RESPONSE TO REQUEST FOR INFORMATION (RRFI) NO. 123

PROJECT: 2299 Dundas Street West, Toronto, Ontario RJC NO. TOR.122388.0002

Shelter Renovation

Subject:	Addition of hub drain in meter room in basement
Ref:

- 1. M-101-Basement-plumbing-layout-snip.pdf
- 2. M-101-Basement-plumbing-layout.pdf

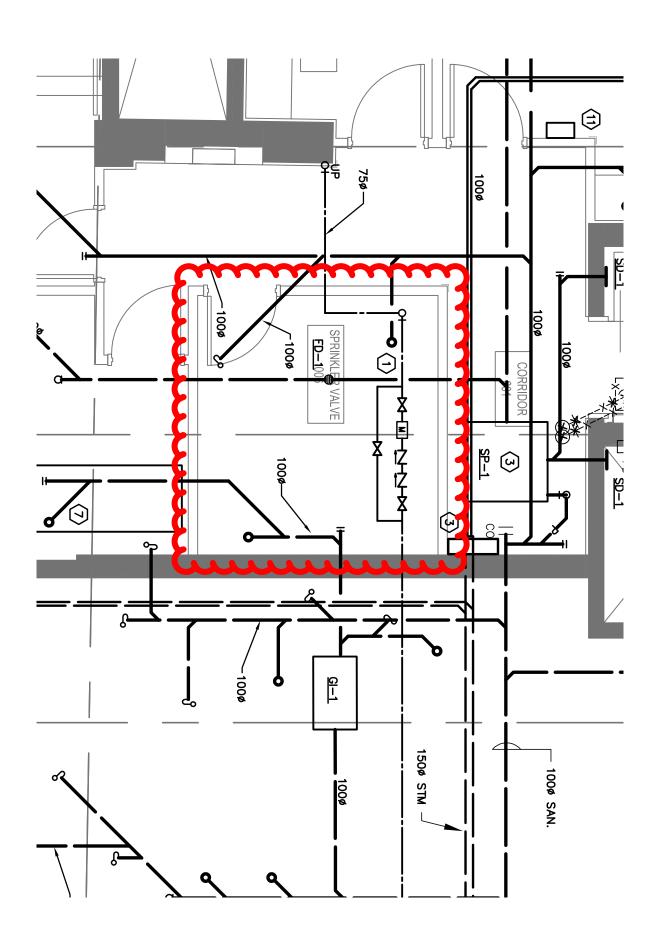
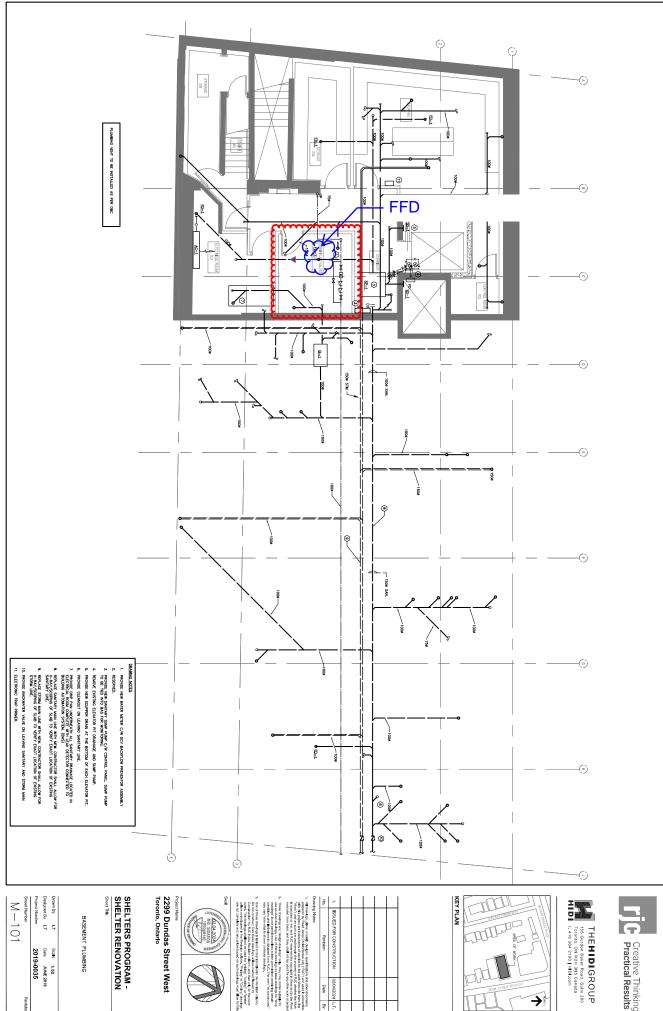
During the inspection, the plumbing inspector requested the addition of a funnel floor drain to accommodate the sprinkler blow-off and meter drains in the meter room. This drain is not shown on the current contract drawings.

Since the drain will need to be sized based on the anticipated flow from the sprinkler blow-off, we require further direction and request for clarification whether we should proceed with the installation of the funnel floor drain as per the inspector's request?

If so, can you provide guidance on the required sizing and location of the drain? can you issue a drawing to reflect this change?

CONTRACTOR TO PROVIDE FUNNEL ON THE FLOOR DRAIN SHOWN IN THE SPRINKLER ROOM AND INSTALL THE DRAIN CLOSER TO THE SPRINKLER ASSEMBLY TO AVOID ANY TRIPPING HAZARDS.

SEE NOTES ON DRAWINGS BELOW.
